**SECTION 00 90 01  
BIDDING AND CONTRACT REQUIREMENTS  
ADDENDUM NUMBER (3)**

**Re: ADDENDUM NUMBER (3) TO THE BIDDING DOCUMENTS FOR**

**Peoria Park District  
Golf Entertainment Facility Renovation an Addition  
Architect's Project Number: 22-051**

SHEET TITLE:  
**FIRST FLOOR - REFLECTED CEILING PLAN**

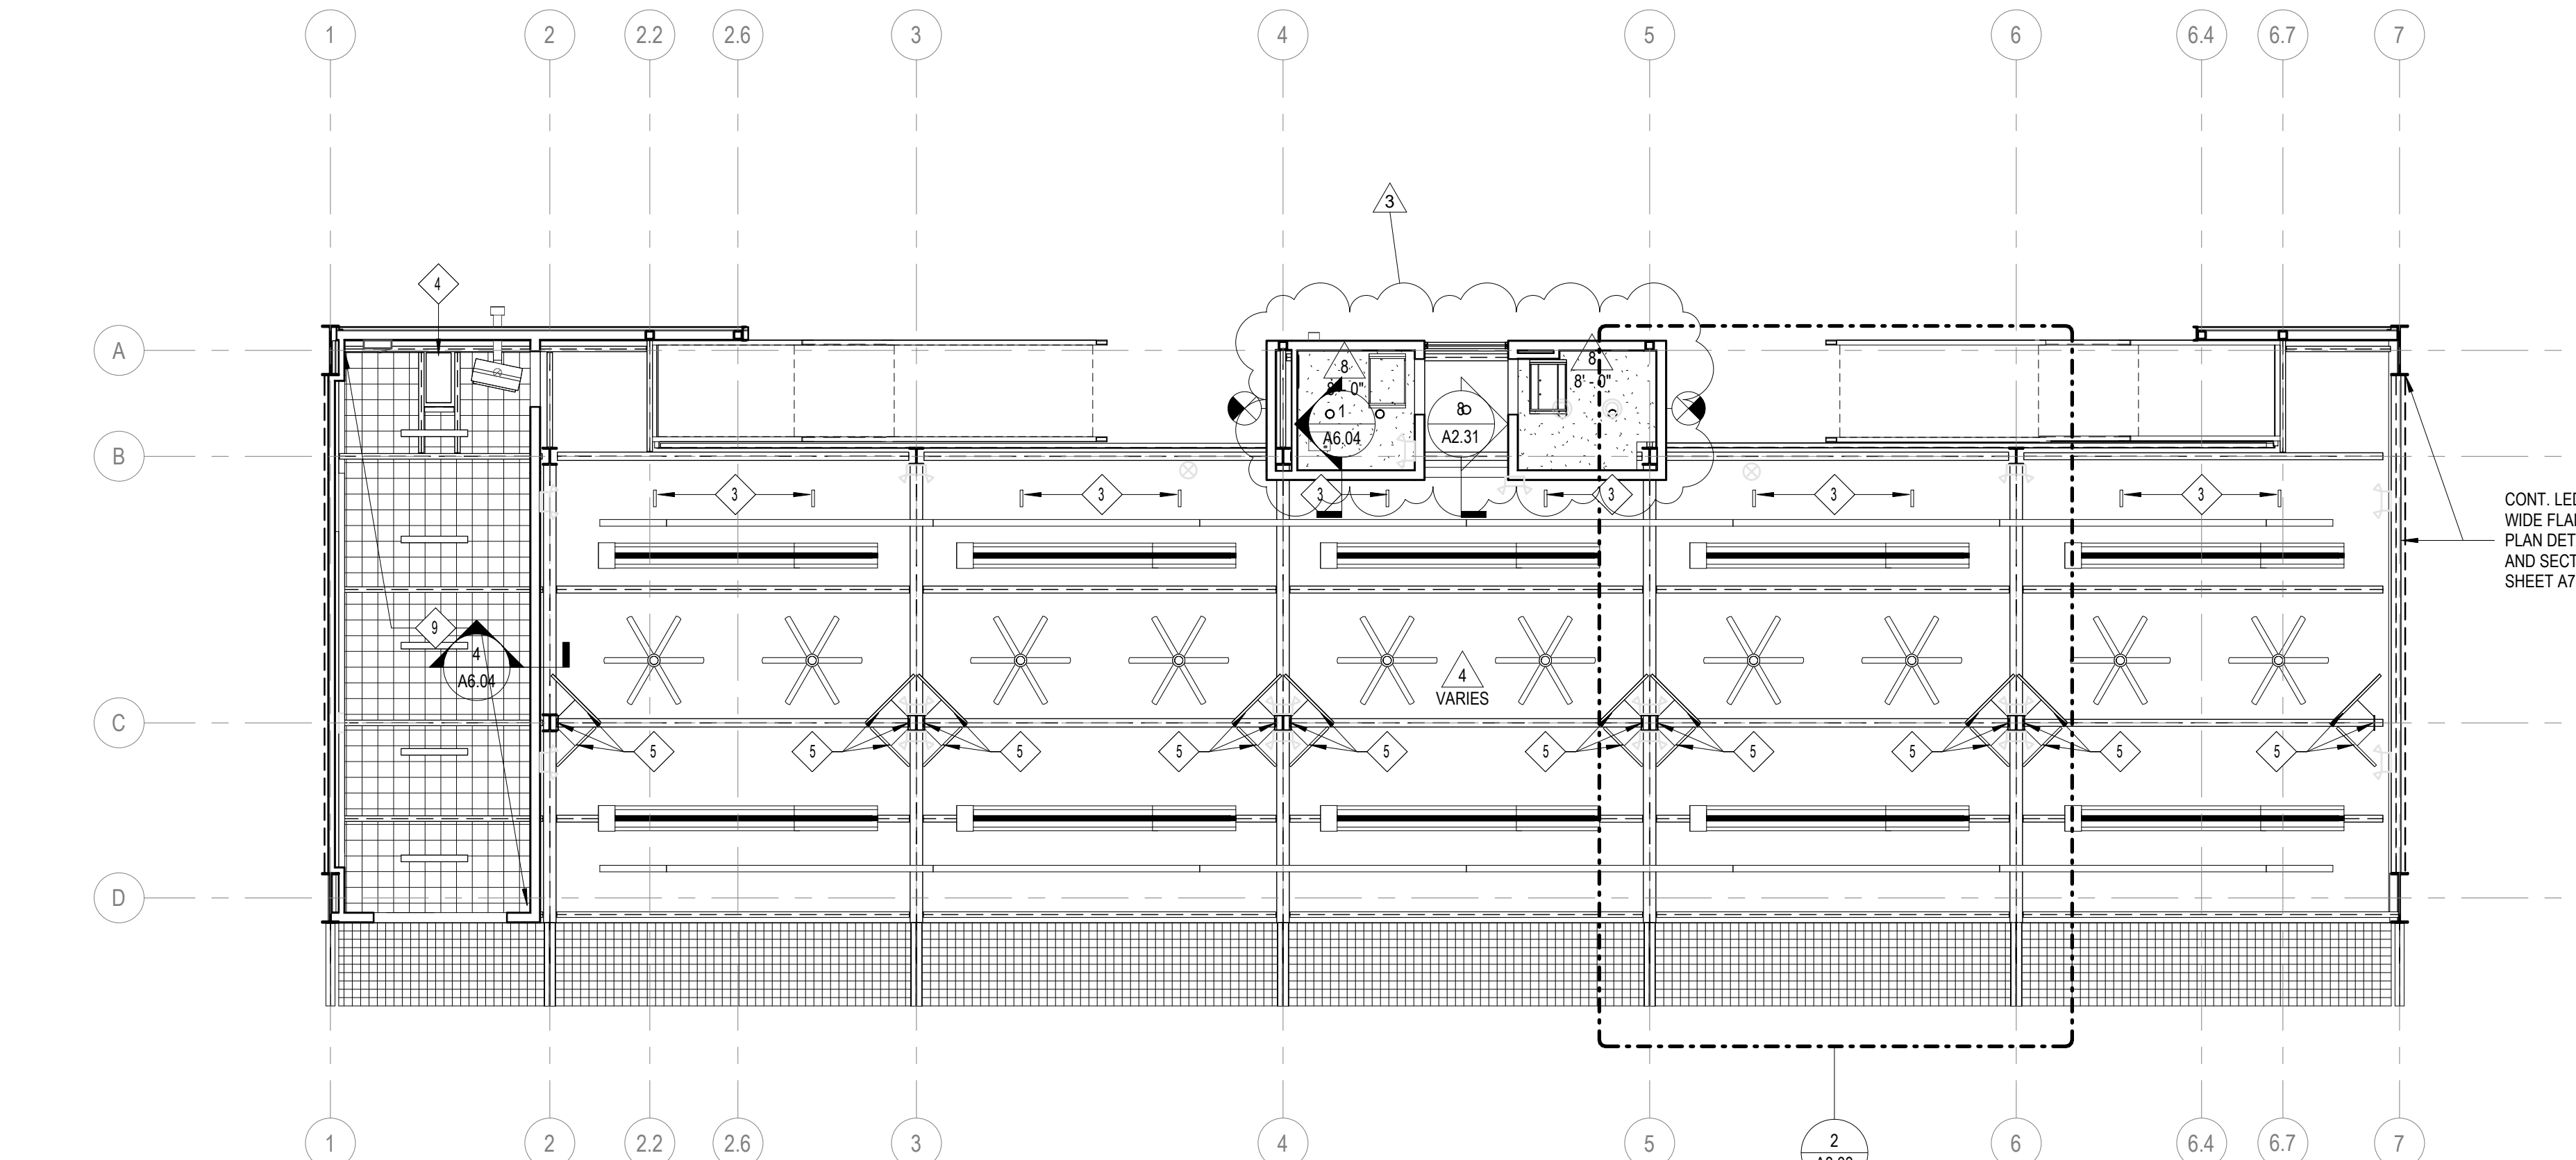
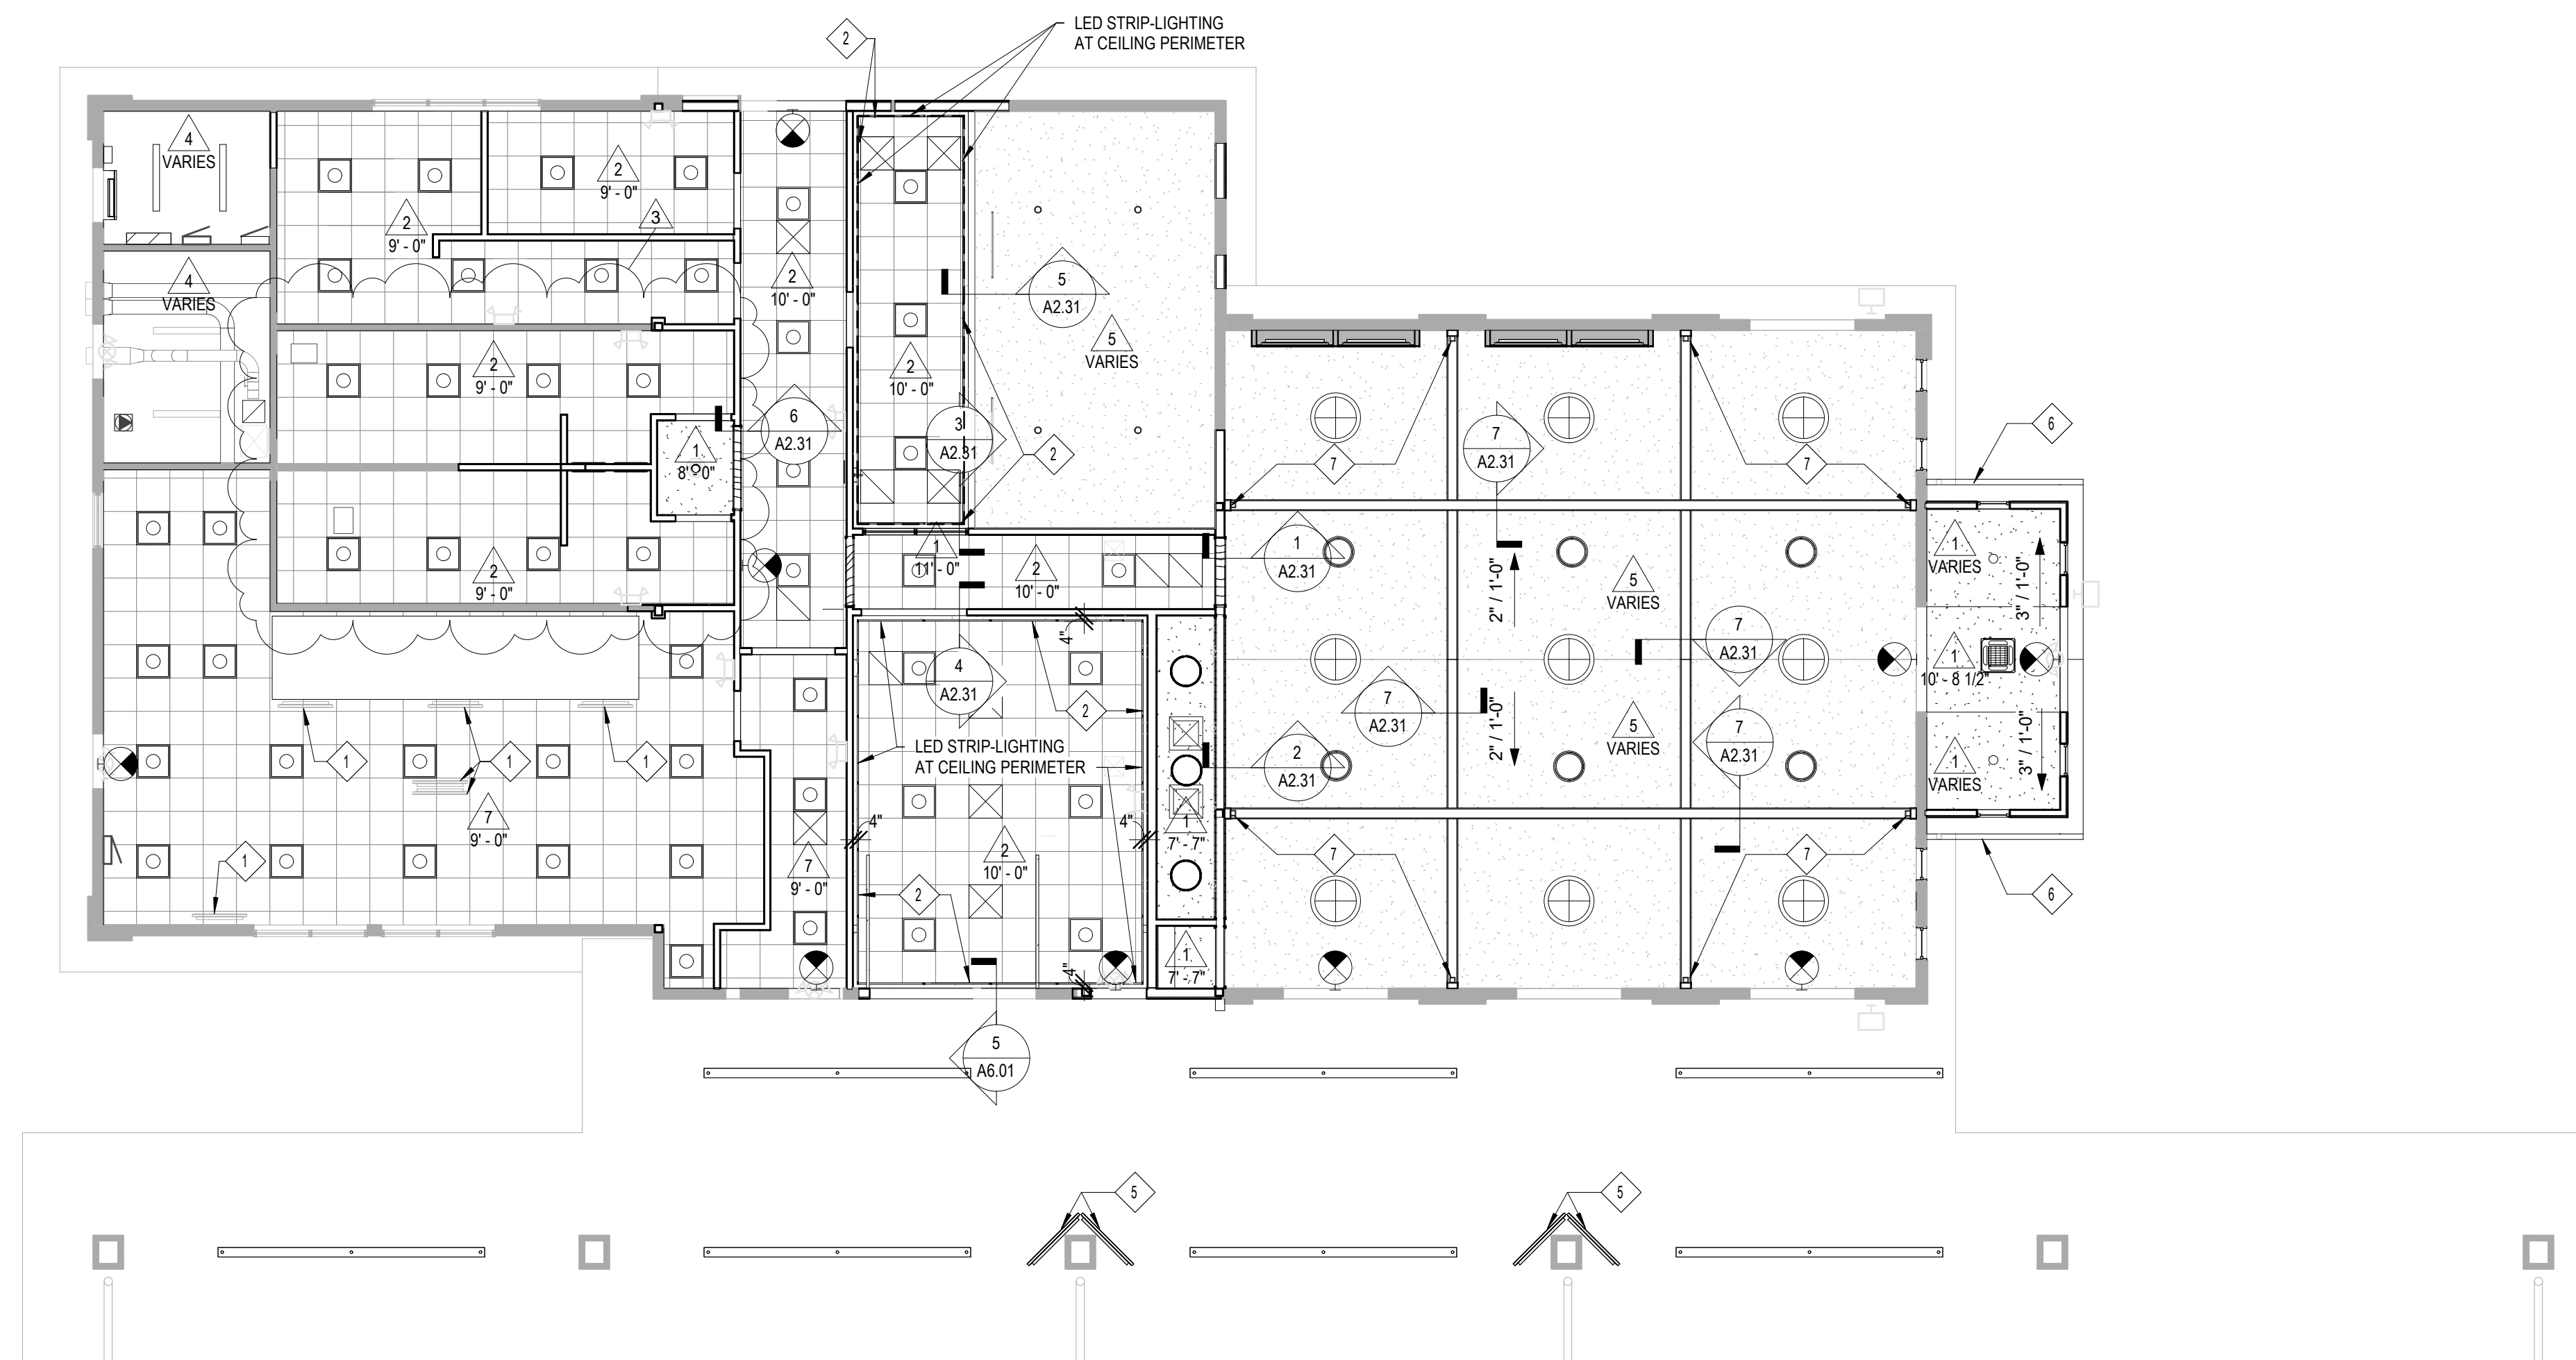
E1.01 Restrooms each show 4 – 2x2 “B” fixtures. A2.11 shows 5 in each of the restrooms.  
4 lights are acceptable per the electrical plans – revised on the architectural ceiling plans attached.

A2.11 Private Event 102 looks to have can lights in the ceiling. These are not shown on E1.01 so I want to confirm if those are can lights or something else.

A2.11 and E1.11 – the can lights don't match in 113, 114 and the space between the two rooms. Same on 2<sup>nd</sup> Floor RCP and E1.21.

Golf simulators are to be provided by the owner. Can lighting shown can be removed. Coordination with owners/ golf simulator rep will be required for lighting requirements.

Architectural ceiling plan revised to match the electrical plans within the restrooms and serving stations. A suspended can light has been added to the electrical drawings to match the architectural. See below.
